Response to the comments

1. Response to referee-1 comments

2. Response to referee-2 comments

Fig. 6: (a) Dimensionless impact energy ($K.E./\rho gh^3$) vs relative wave amplitude, indicating a nonlinear trend, (b) Wave energy vs relative wave amplitude, indicating higher wave amplifications in shallow waters.

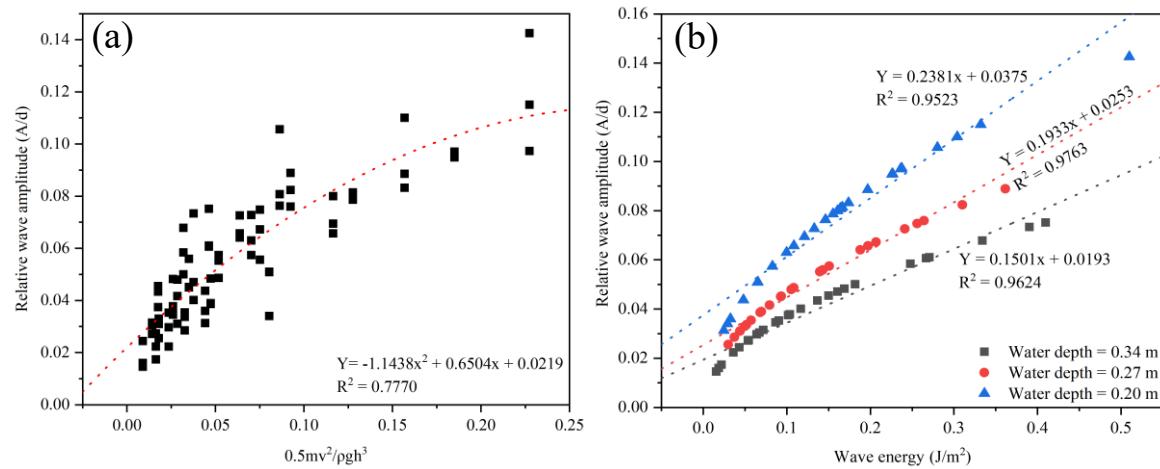
4. "The negative quadratic coefficient in Fig. 6(a) indicates a nonlinear response, such that at the start the wave amplitude increases as the impact energy increases, but after a certain value it decreases, due to reduced energy transfer at higher impact values." Please elaborate on why energy transfer decreases.

Response: Thanks for your valuable comment. We have added details on why the energy transfer decreases in the revised manuscript. "At higher impact values, the released energy was not fully used in the wave formation and propagation; instead, a part of the energy was dissipated in the formation of splash, and in the formation of air pockets and their subsequent collapse". Lines (361-364).

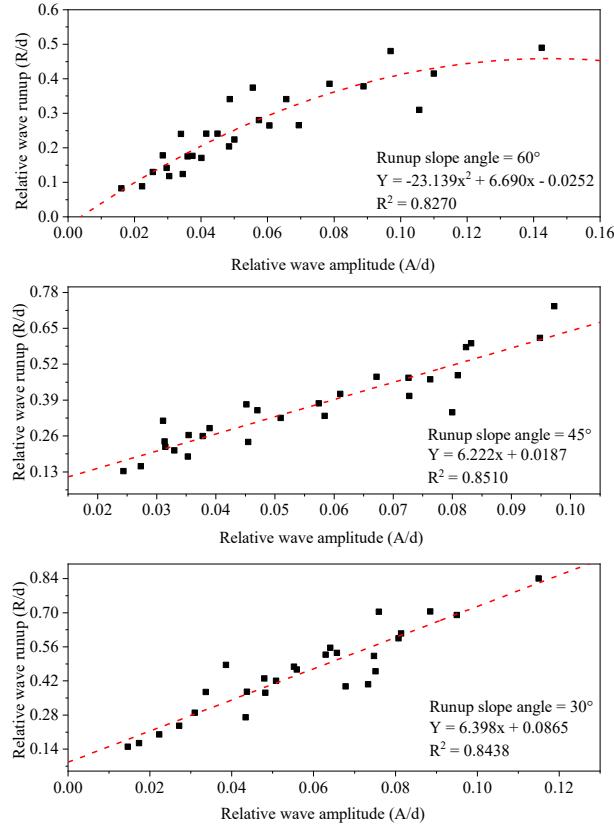
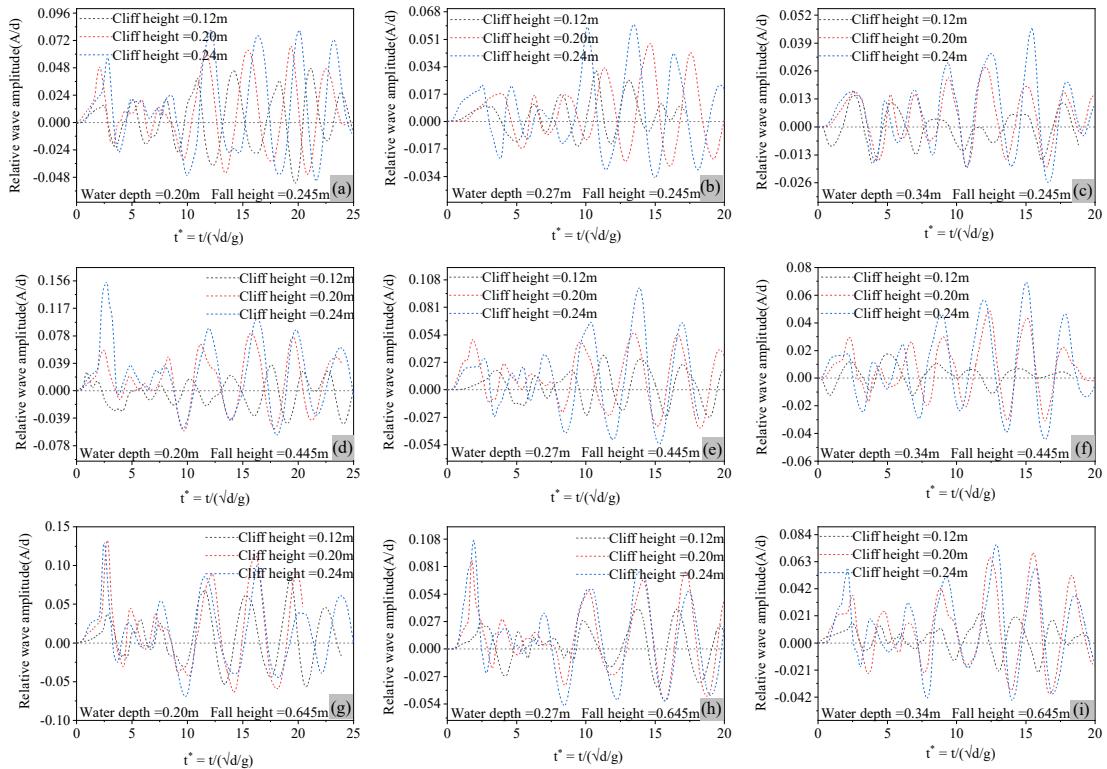
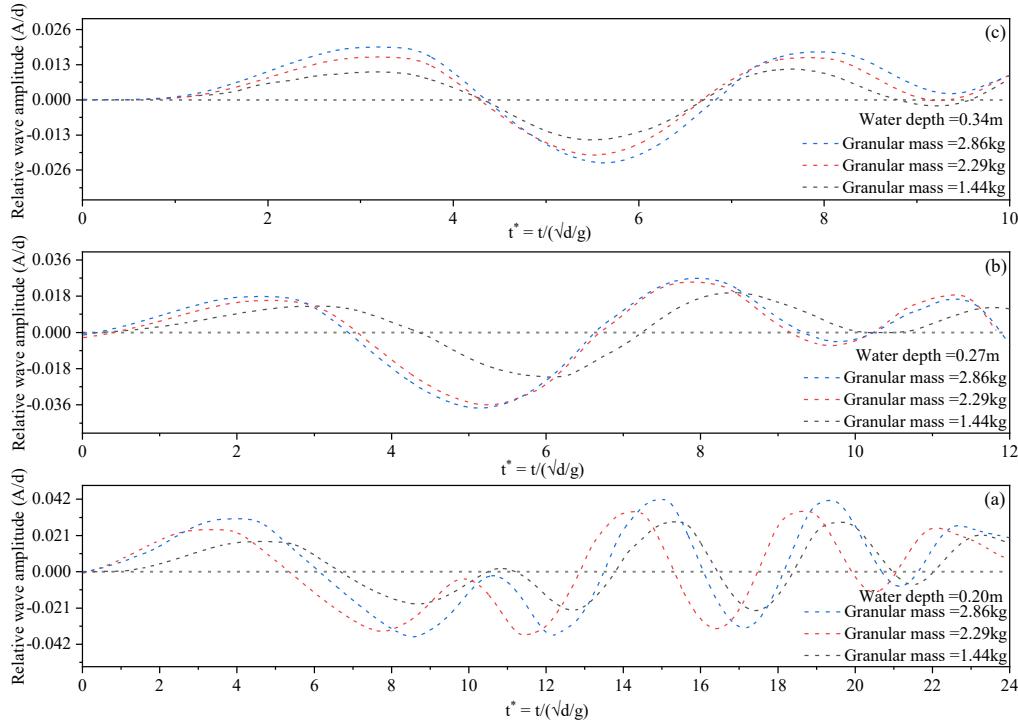
6. To enhance the **quality and clarity** of the **figures** in the manuscript, it is strongly recommended to revise all the figures (preferably using Origin and/or MATLAB) and add more relevant explanations to the respective captions (they must include relevant details such as the data source, experimental conditions, and any important observations or trends depicted in the figure).

Response: Following the instructions, all the figures have been redrawn using Origin, and a more relevant explanation has been added to the captions of the following figures in the revised manuscript.
